## **Staff Report**

### **Public Hearing: Juniper Ridge Subdivision**

Preliminary Plat, Legal Lot Determination, SEPA Mitigated Determination of Non-significance (MDNS),  
Variance, Critical Areas Permit, and Tree Cutting Permit: Type III Review (File #2025-005-PLD)

Figure 3: Proposed Preliminary Plat

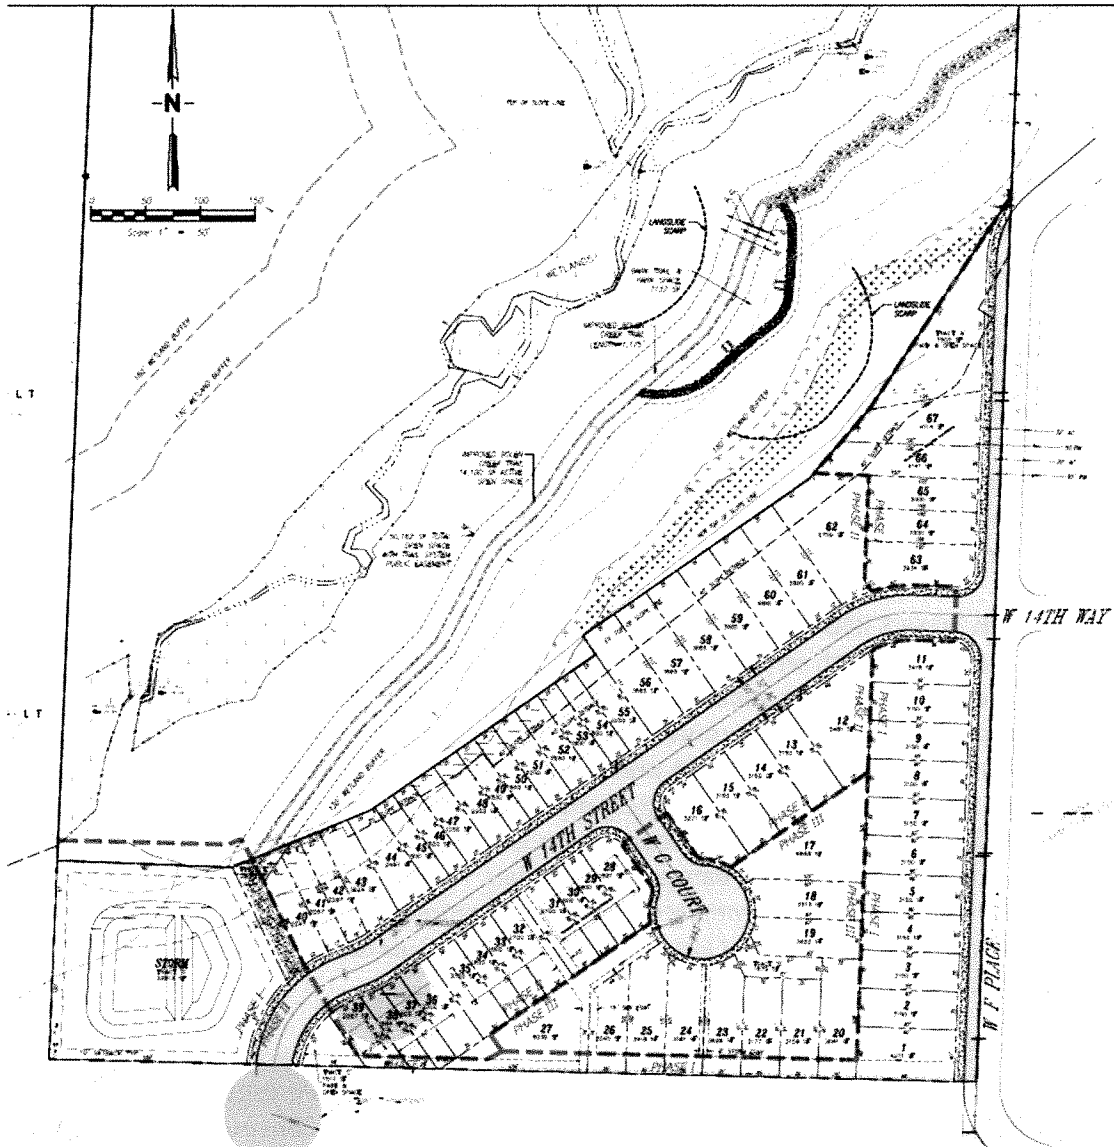
The applicant is proposing to develop this site three phases. The preliminary plan identifies the boundaries of each phase, and the proposed stormwater and park facilities are included in the first phase. The sequence of the phases allows the project to maintain compliance with all applicable standards. The applicant is required to submit each phase so it can stand on its own.

***As a condition of approval, the phases must be submitted as shown on the proposed plan.***
